Re: Mediterranean Village Review - #14153
Traffic Impact Study, Parking Analysis & Valet Operations Analysis

David Plummer and Associates (DPA) have completed several reviews of the Traffic Impact Analysis, Shared Parking Analysis, Parking Garage, and Valet Operation Analysis conducted for the proposed Mediterranean Village project. A summary of these components is below.

HOTEL DROP-OFF - OPTION #1 "ORIGINAL SUBMISSION"

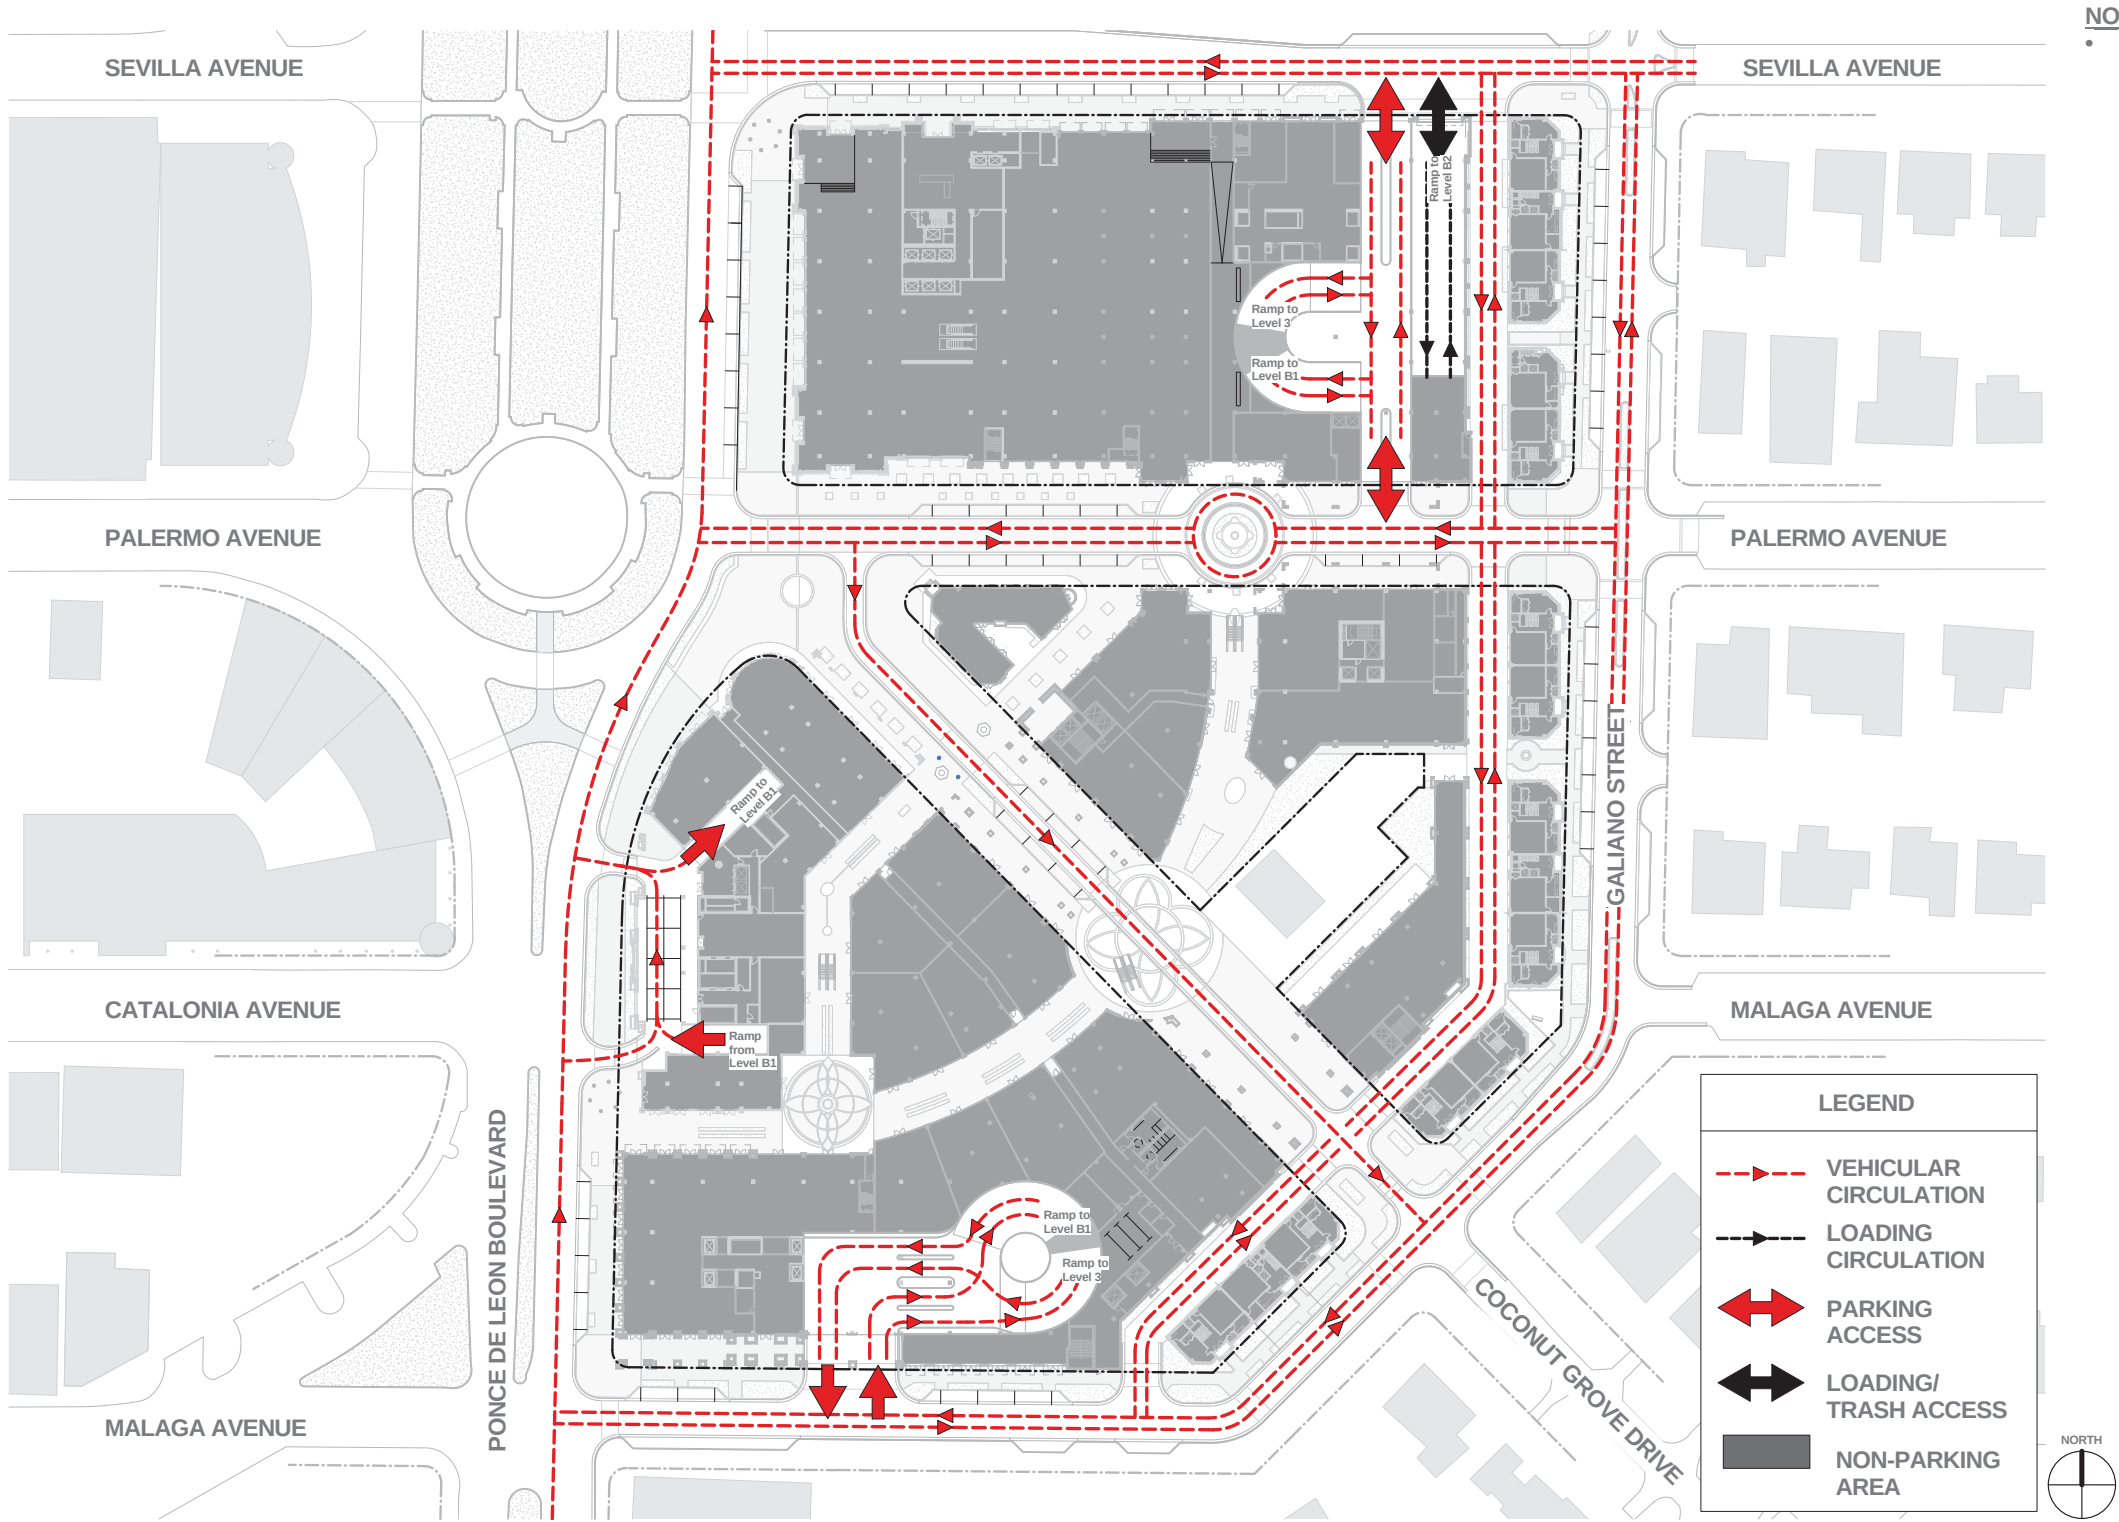
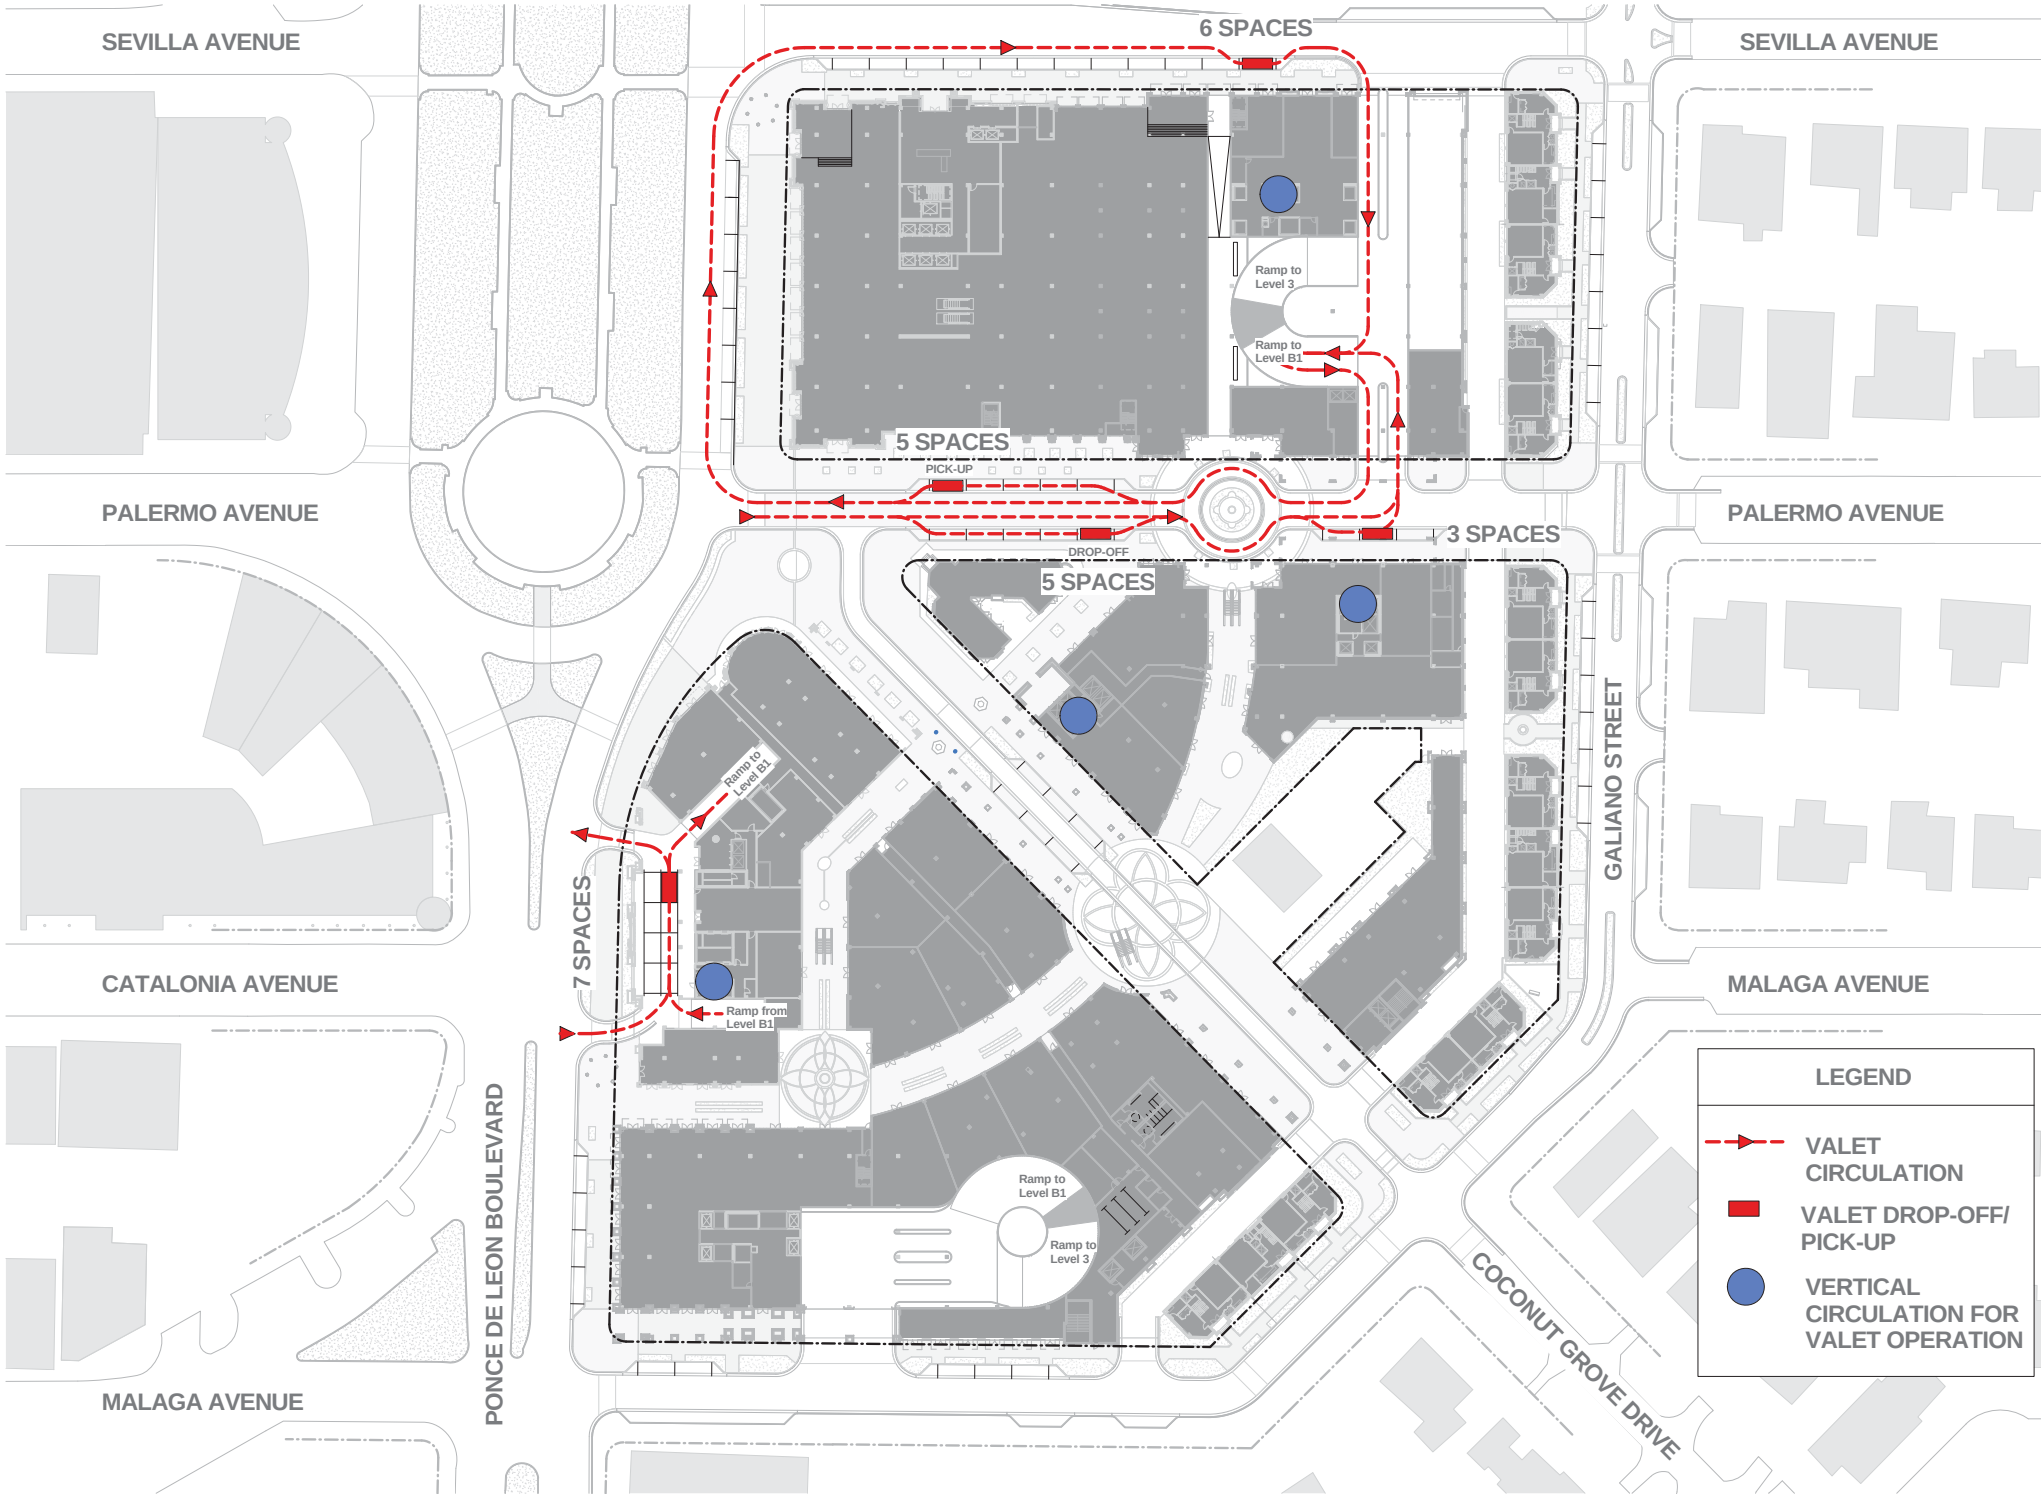
During first reading, the project included direct access to the hotel from Ponce. This access plan for the hotel was acceptable. The project has since changed to address comments from the Commission. Of the newly proposed options, Option 3 is an acceptable alternative and preferable to Option 2 provided that the following conditions are included: 1) the hotel valet ramps will be completely segregated from the Malaga driveway ramping system and no traffic from Malaga would be allowed to access the hotel's porte cochere, and 2) two one-way ramps (similar to the Ponce alternative) or a two-way, two-lane ramp for hotel valet use only is provided. See attachments for hotel access options.
